# STREAM AND WETLAND ECOLOGICAL ENHANCEMENT PROGRAM (SWEEP) ISSUE TASK FORCE (ITF) MEETING MINUTES

I-70 Floyd Hill to Veterans Memorial Tunnels

Project:	I-70 Floyd Hill to VMT
Meeting:	SWEEP Issues Task Force Meeting
Date:	April 17, 2018; 1:00 pm to 3:00 pm
Location:	CDOT Region 1, 425 Corporate Circle, Golden, CO

**Project:** I-70 Floyd Hill to Veterans Memorial Tunnels NEPA and 30% Design Meeting: 21912 Floyd Hill SWEEP #2 Date: October 25, 2018 CDOT Golden Region 1, Lookout Mountain Location:

# PROPOSED SEDIMENT CONTROL LAYOUT

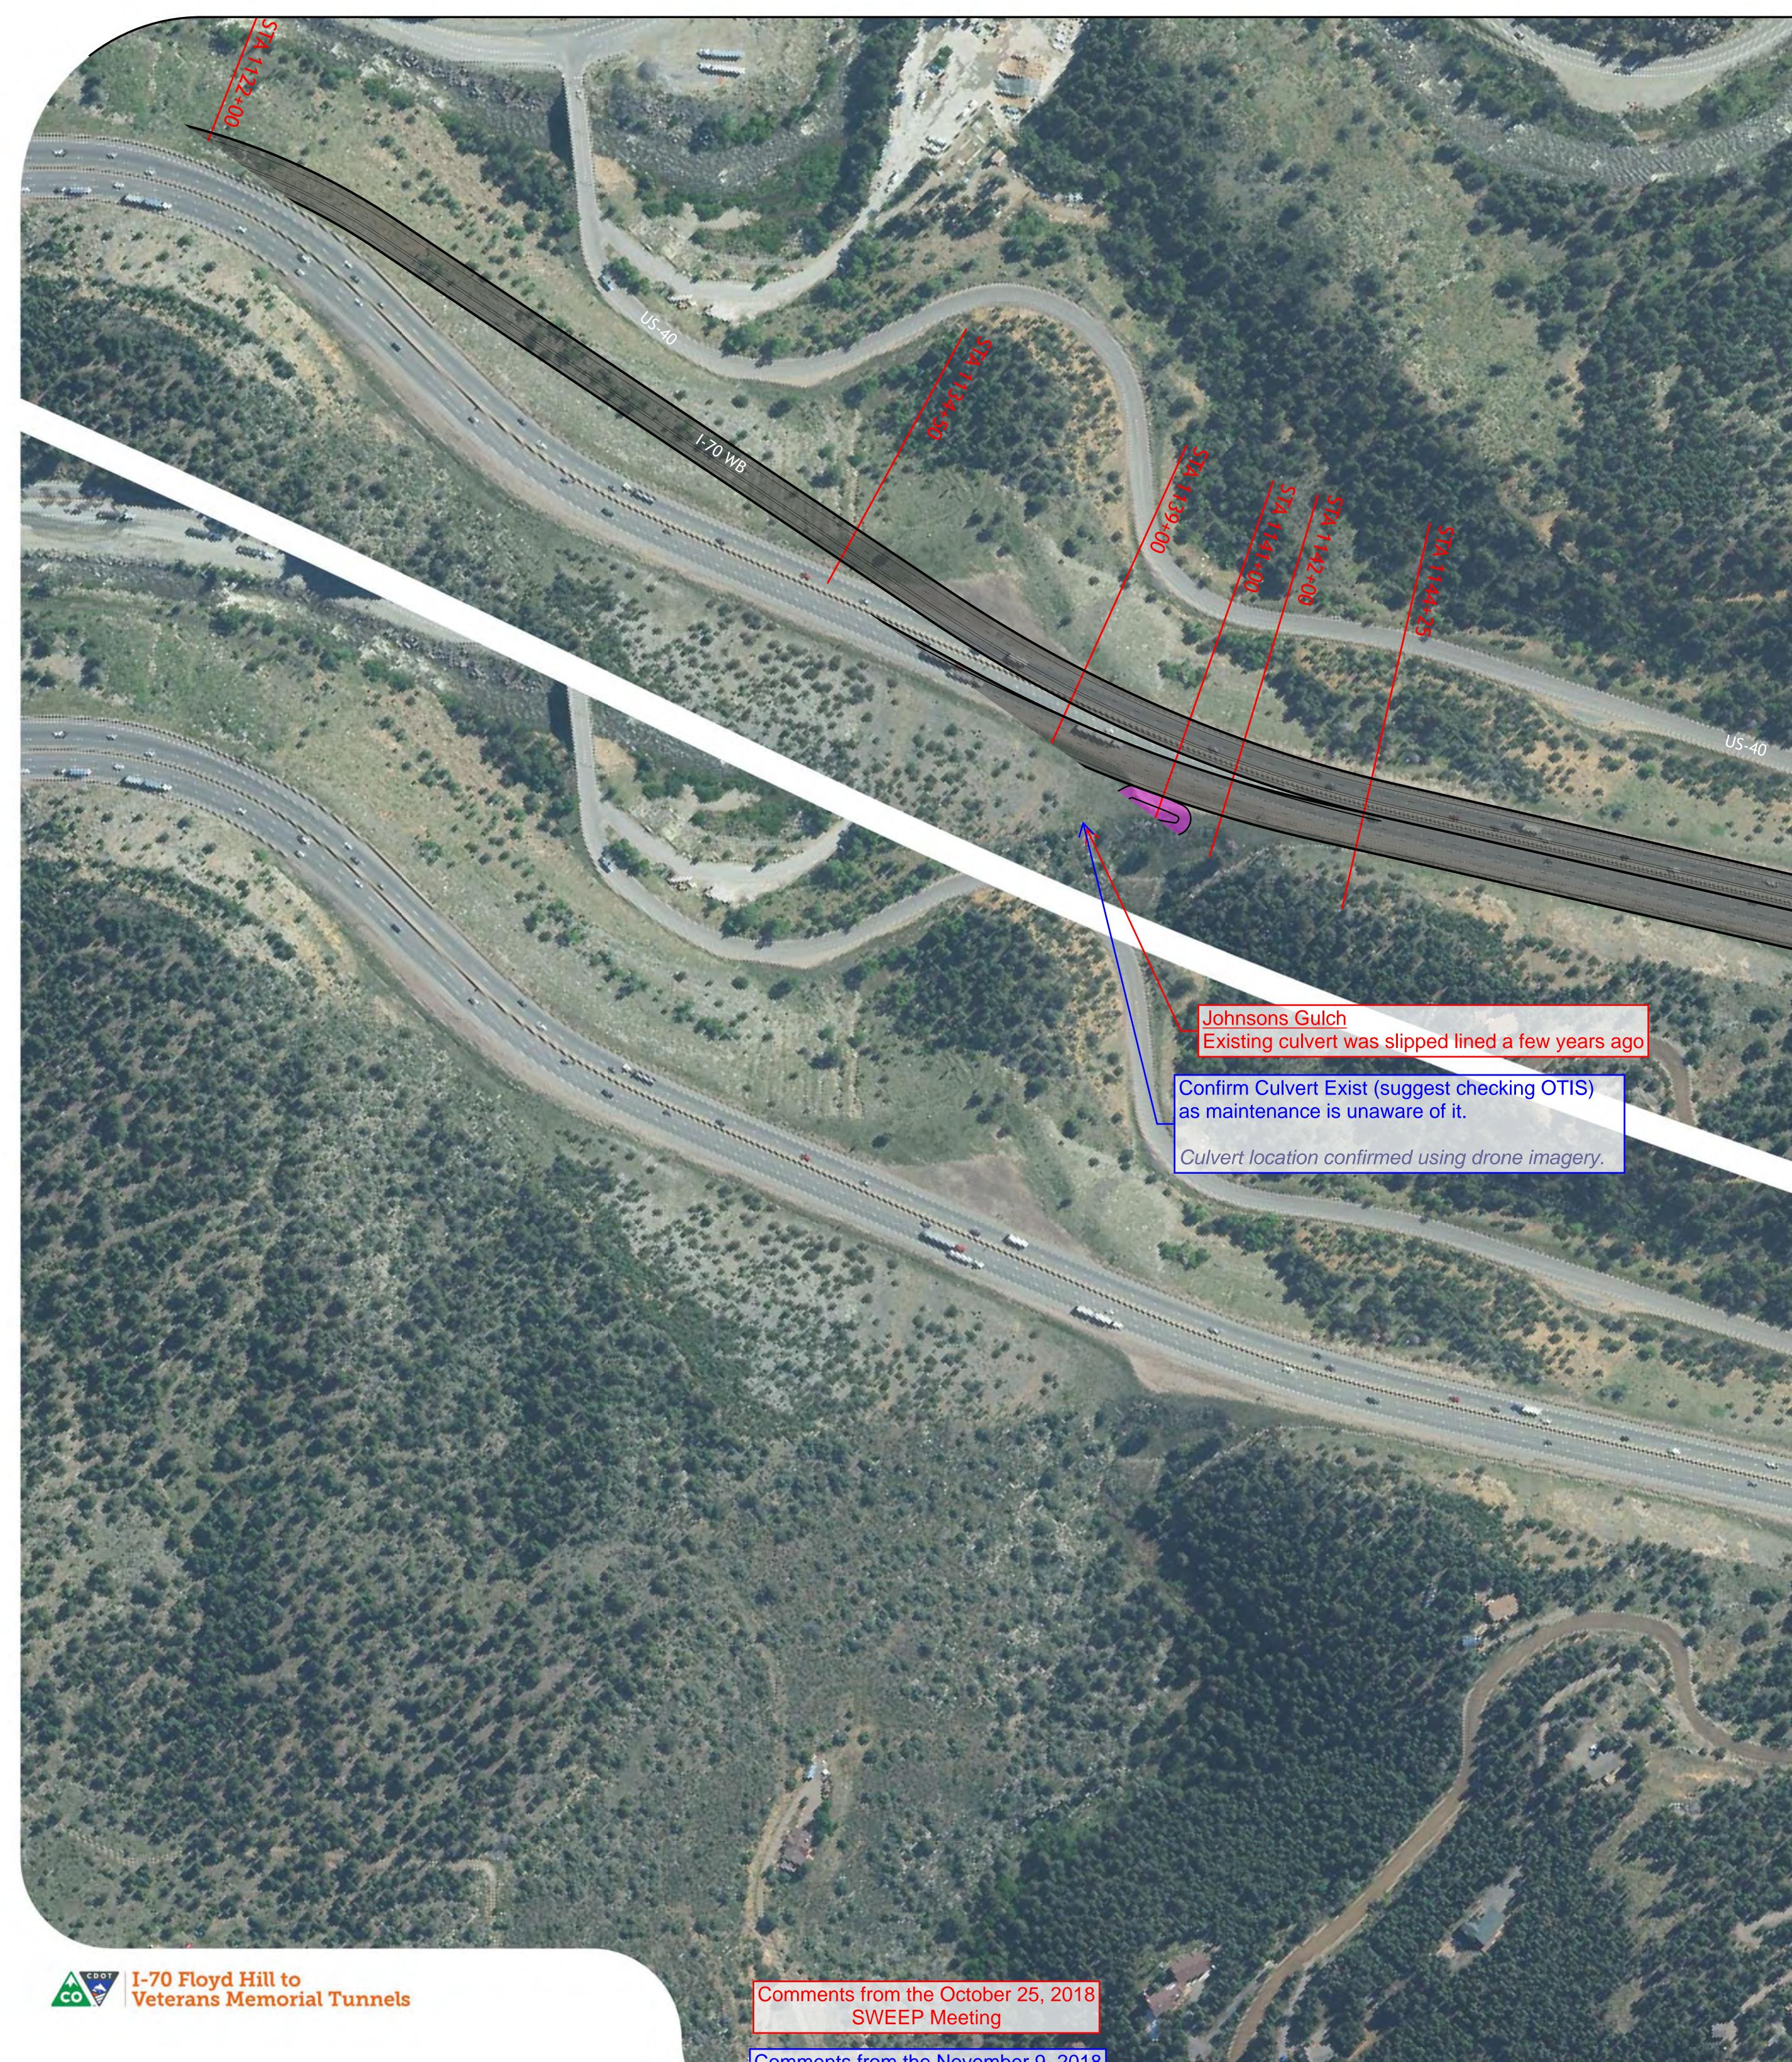
- (ii) Jo Ann Sorenson receives annual reports on the sediment basins from the EB PPSL project that show the structures are not capturing sediment. Need to design them so that they work. Based on discussions with Maintenance after the meeting, the lack of sediment may also be due to the lack of sand use in the area.

- ii) Sediment Basins:
  - a) 27 shown in the SCAP
  - b) 12 Proposed with the Project design
- iii) Roadside Swales
  - a) Proposed with the Project due to limited right-of-way and trying to limit the Project's disturbed area.
  - b) The swales will provide some treatment of runoff prior to being discharged into Clear Creek
- iv) Loading Dock Traps:
  - a) 3 shown in the SCAP
  - b) 1 proposed with the Project because there is no room for a sediment basin in that area.
  - c) The location is not in a highly visible area based on the current proposed design and the design will ensure that it is as minimally visible as possible
- v) Inlet Sediment Traps:
  - a) 26 in the SCAP
  - b) None proposed for the Project
  - c) Dangerous and difficult to maintain because Maintenance has to do lane closures at night to clean them
  - d) Not effective because they are not maintained

- c) Recommended communication and hand off; provide a map of BMPs to:
  - i) Maintenance
  - ii) Fire response
- d) Design considerations/review:
  - Station 1022+00: Capture area (tunnel to bridge) sediment basin is just upstream of the intake: Proposed design must not impact or modify the existing water intake for the Black Hawk water treatment facility

- (a) Approximate location is north of the highway and may be in between I-70 and Central City Pkwy to the west of the treatment plant
      - (b) Need to coordinate with Central City because this location is one of their PWQ features
